## **Mallard Pass Solar Farm**

**Preliminary Environmental Information Report**

**Appendix 2.1: EIA Scoping Report**

**Scoping Report**

**DWG. NO. Figure 2.1**

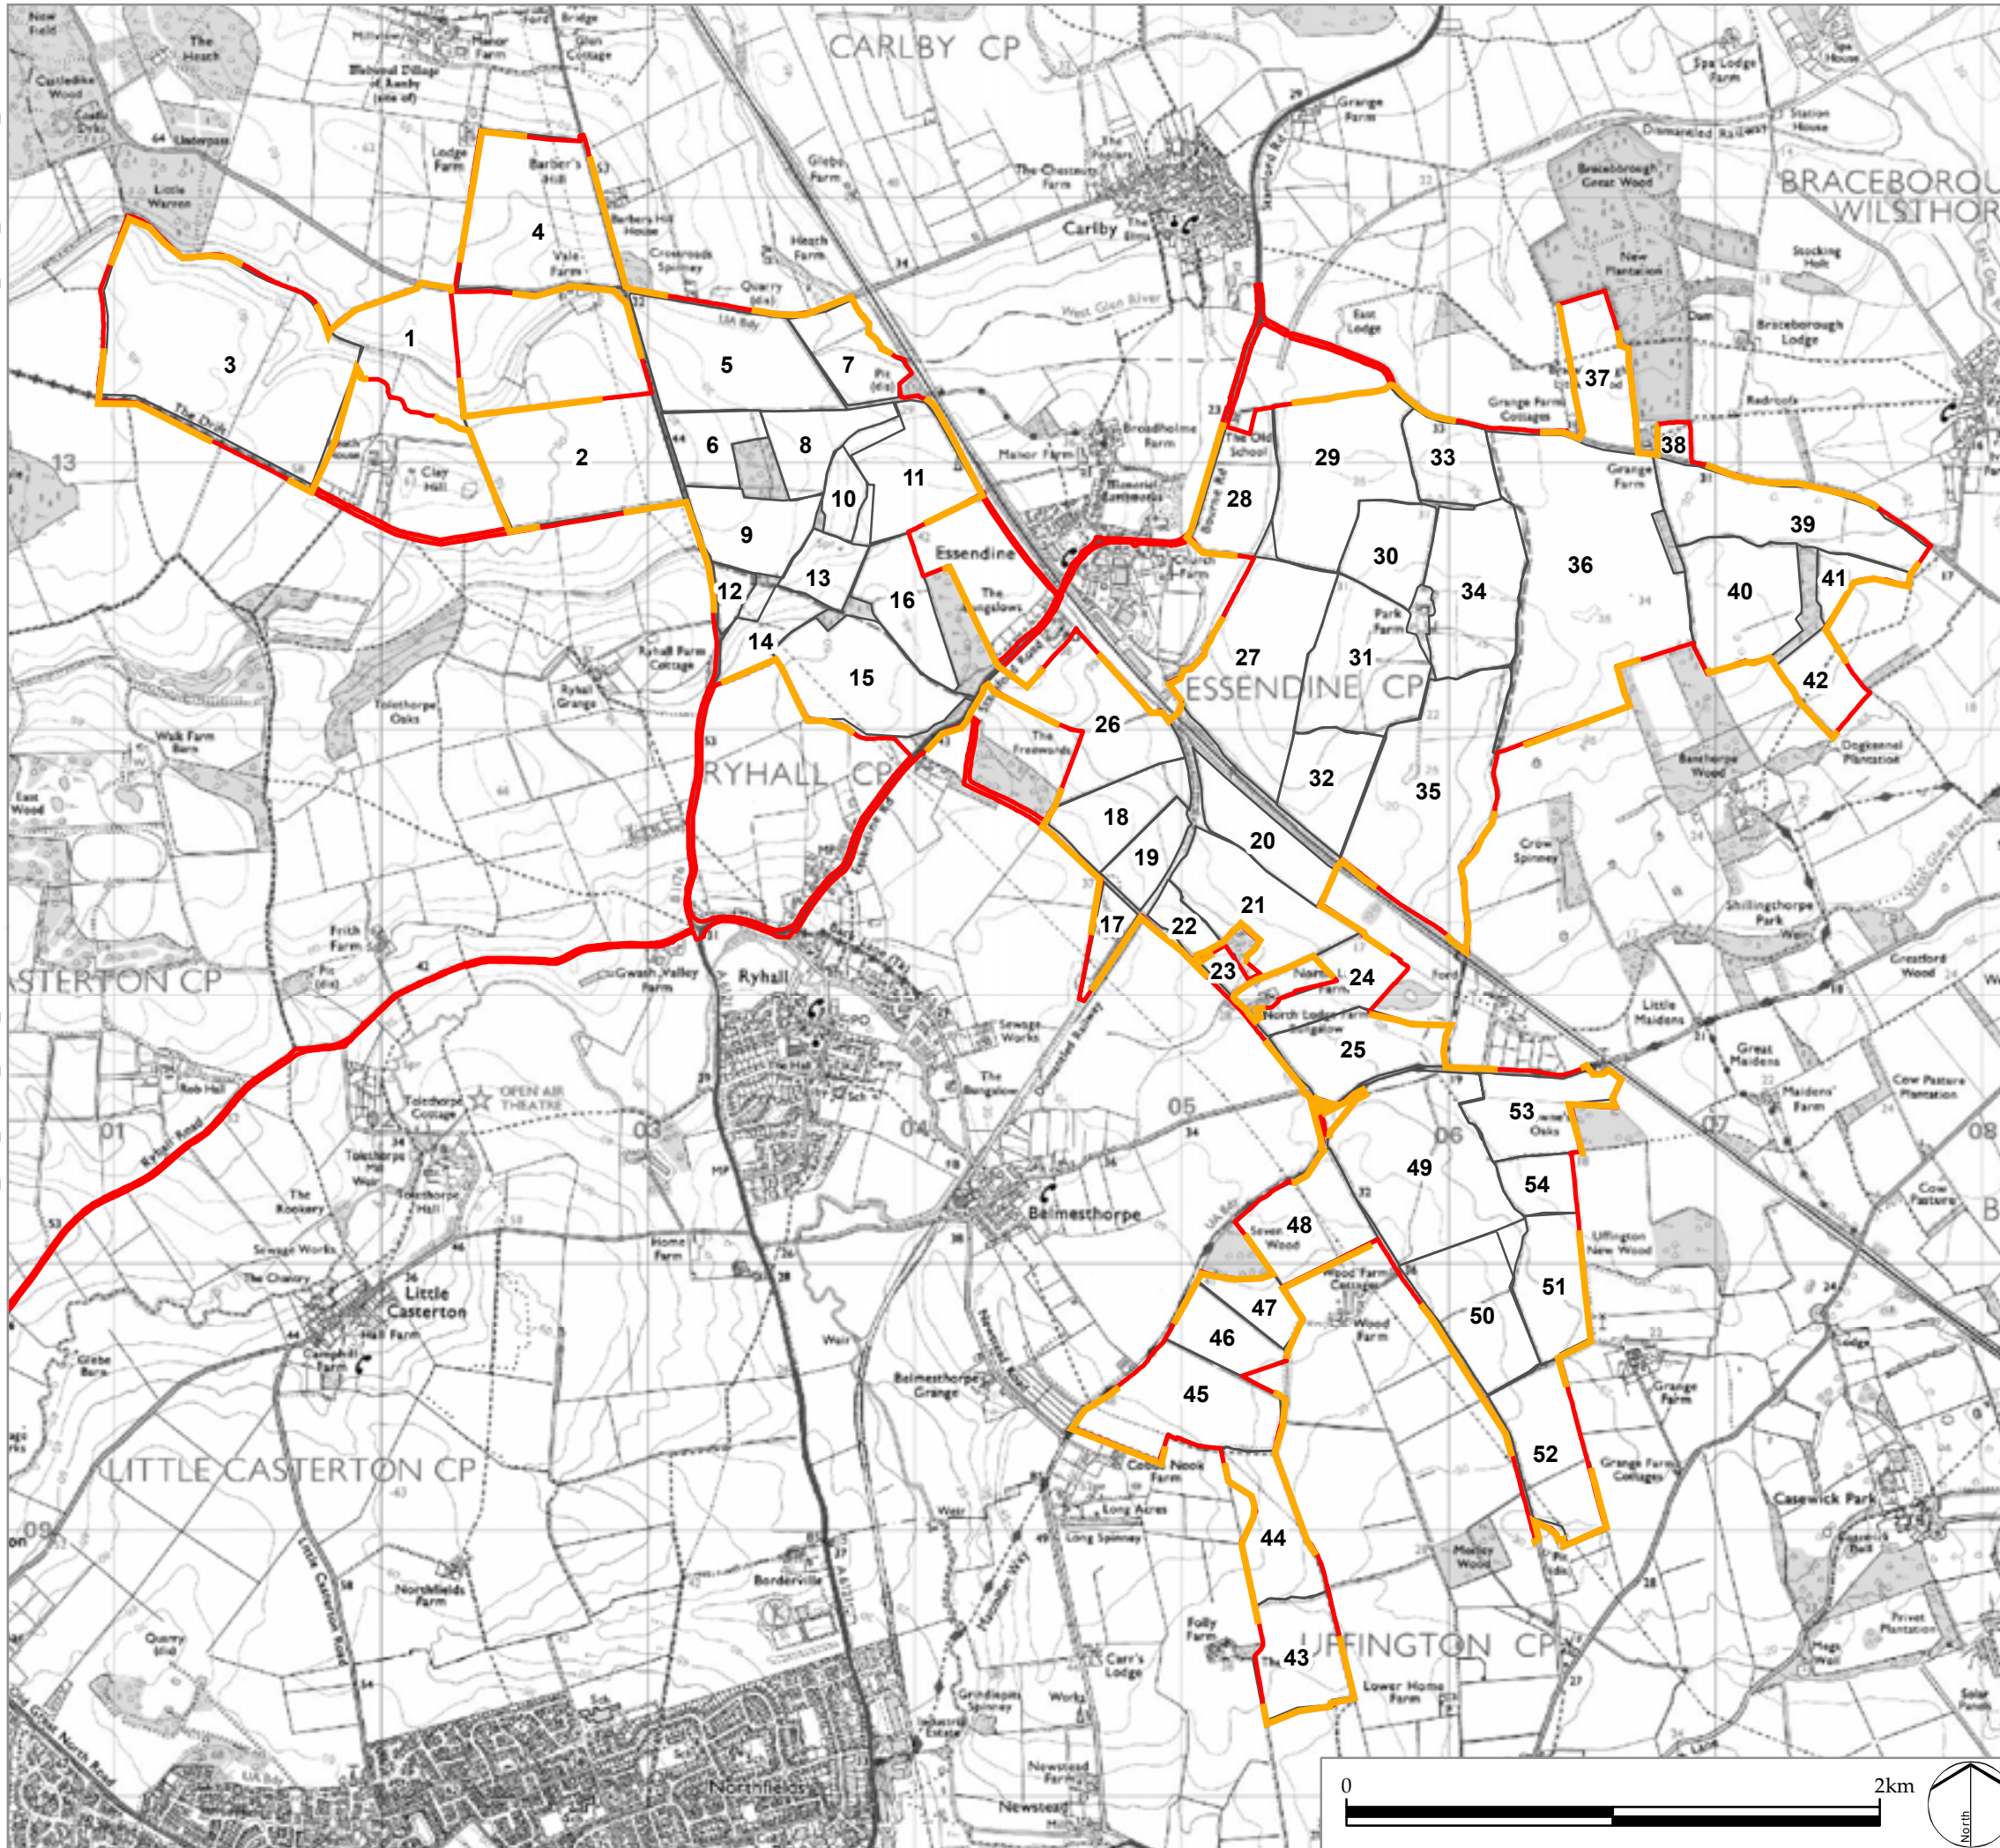
ID	Ref	Description	Inspectorate's comments
2.1.1	Figure 2.1	Site Location Plan	The site location plan depicts the site boundary, which includes the whole of the Proposed Development and the Solar Photovoltaic (PV) site boundary (the area for the panels). The boundary lines overlap in places and the same or similar key colours are used, which prevents a full understanding of how the boundary of the Proposed Development relates to the solar PV site. In addition, certain fields or sections of fields within the site appear to be excluded. The ES should include a figure or figures that clearly set out the Proposed Development boundary and the land included therein.

- Figure 2.1 P26. The chart is misleading as the red/orange denote the solar PV site, when in fact those areas also include all the mitigation areas.
- Figure 2.6 P30. Water Resources and Flood extents. This chart does not show the impact on Greatford outside the site, and it only highlights 1 in 20 as the worst case scenario. As above in 2.4.2 we know there is ongoing flooding in Greatford and at the bottom of Essendine hill on a regular basis and the flood risk is likely to increase owing to climate change.

**DWG. NO. Figure 2.3**

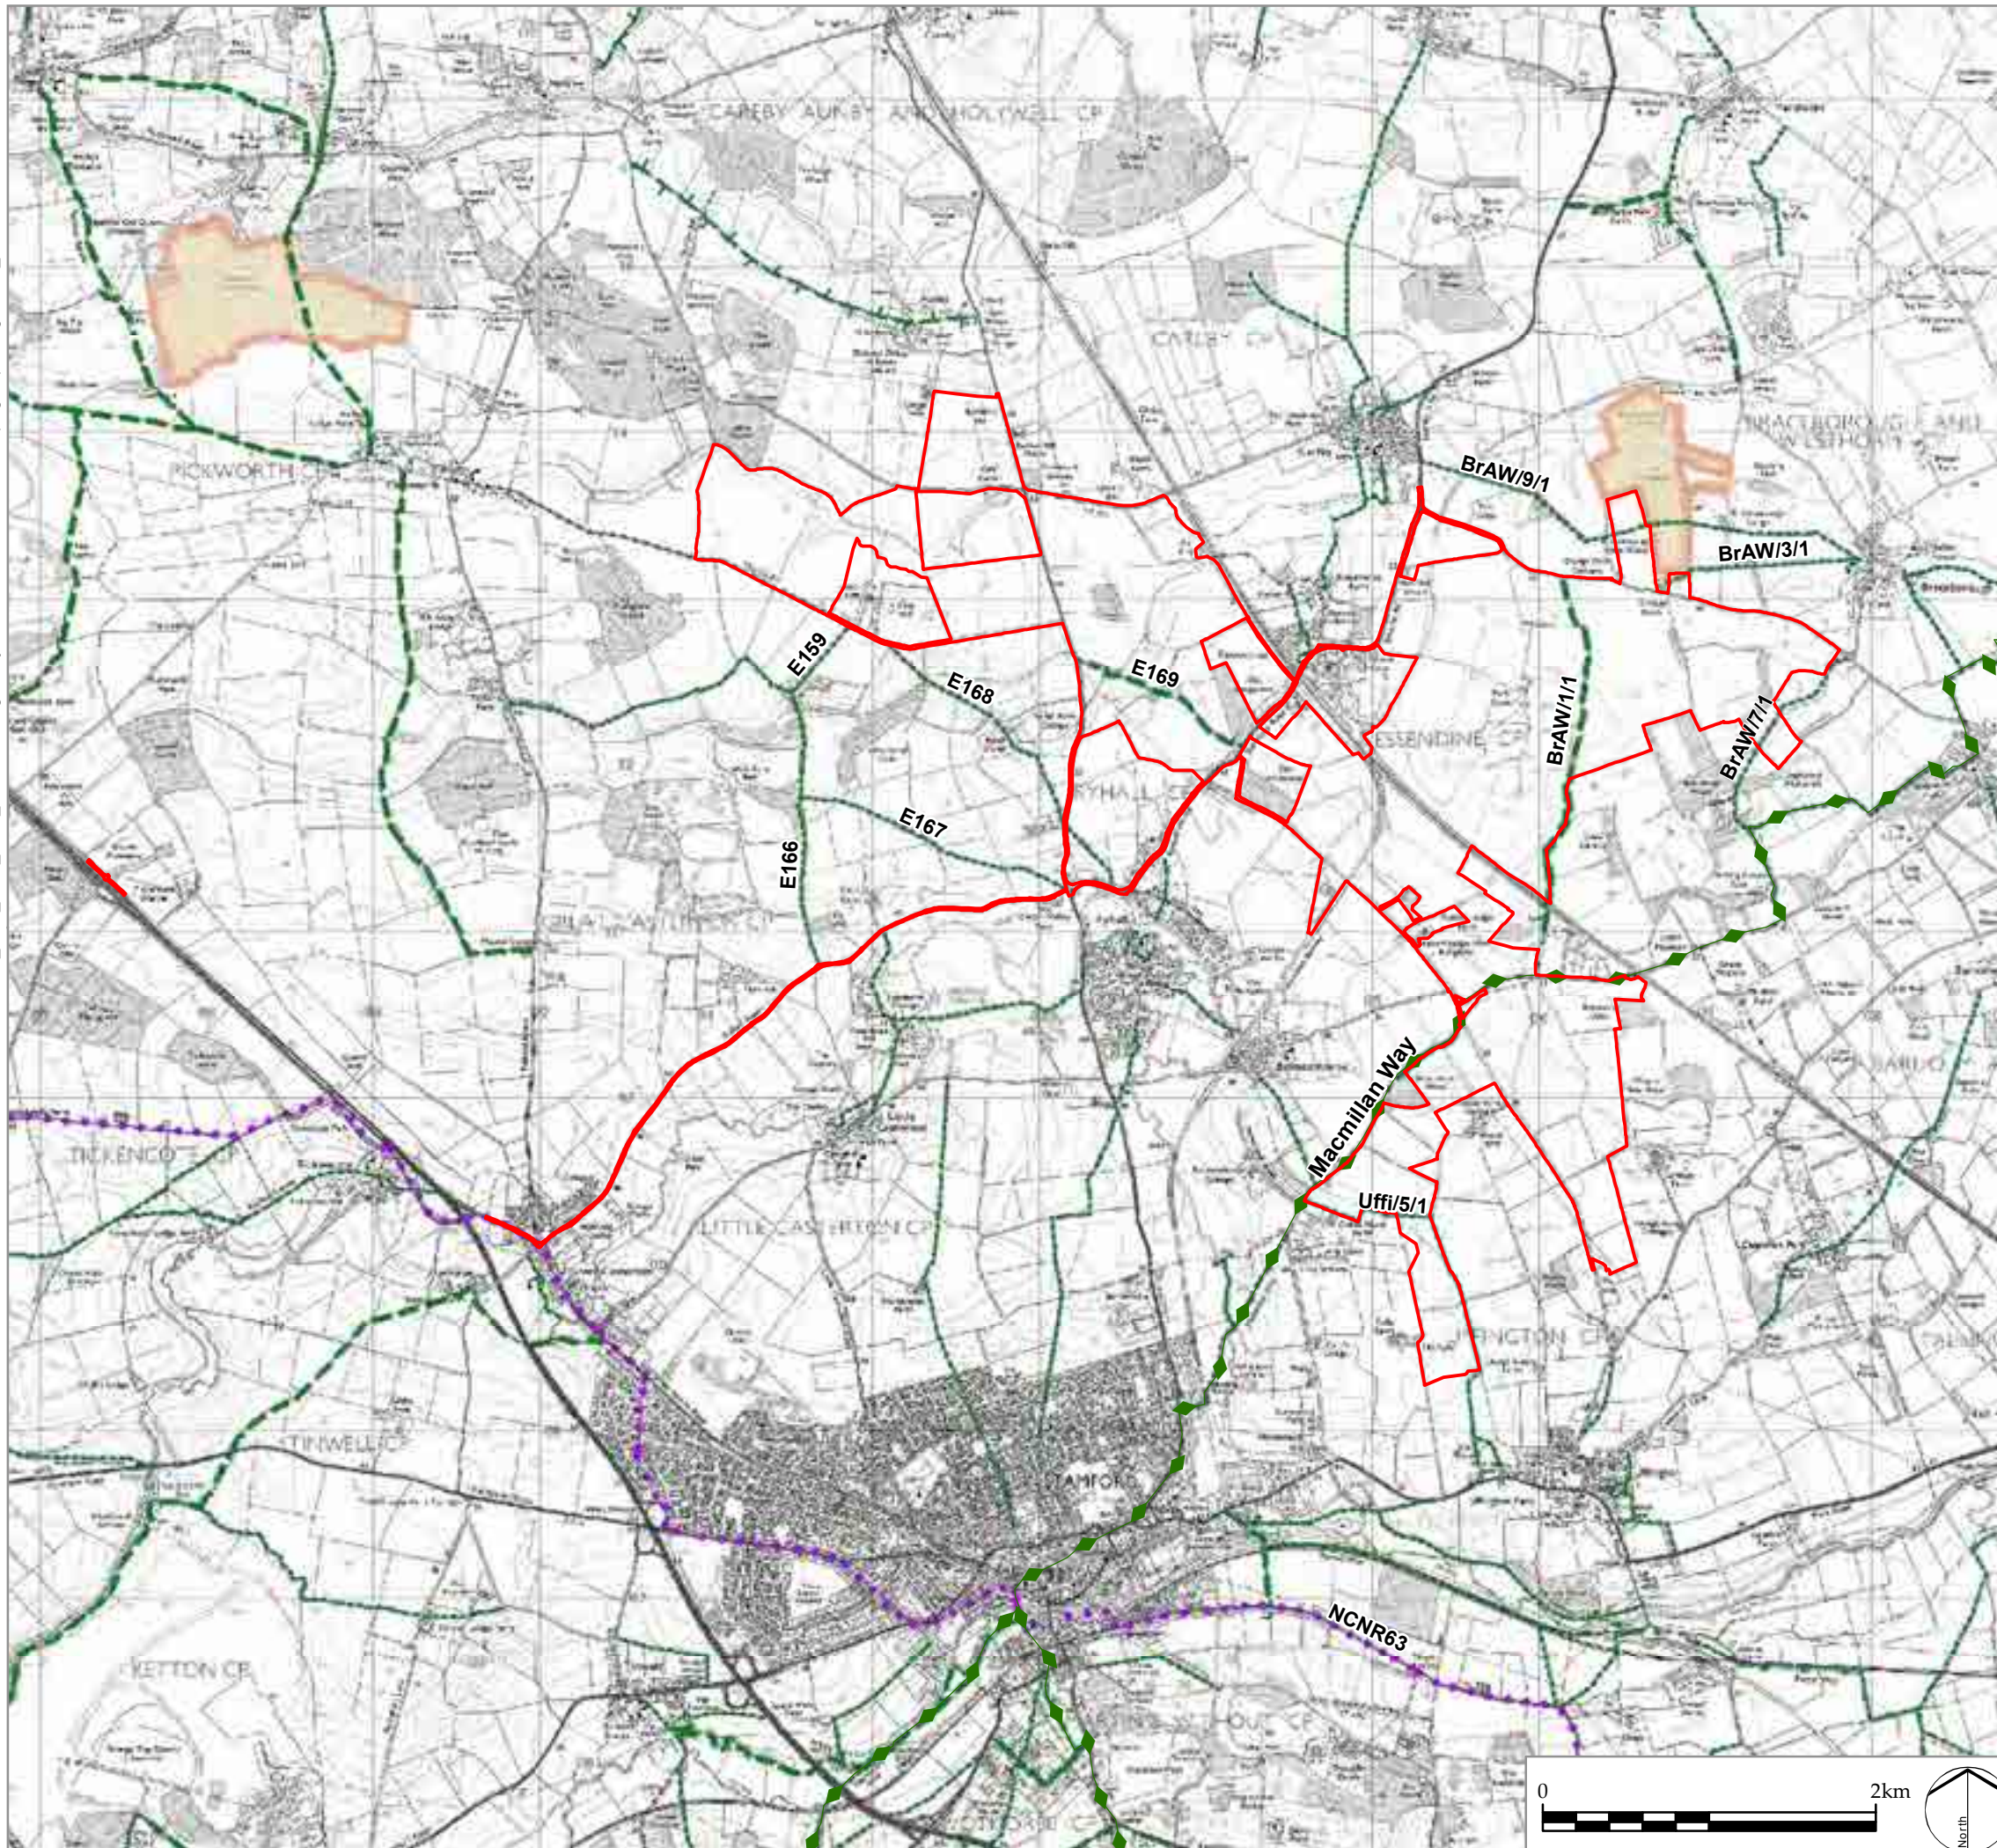
2.1.2	Figure 2.3	Topography	The topographical plan included in the Scoping Report lacks clarity regarding the land that is included in the redline boundary. It appears that certain field areas have been excluded from the red line boundary. The ES needs to include plans which clearly show the land required for the Proposed Development.
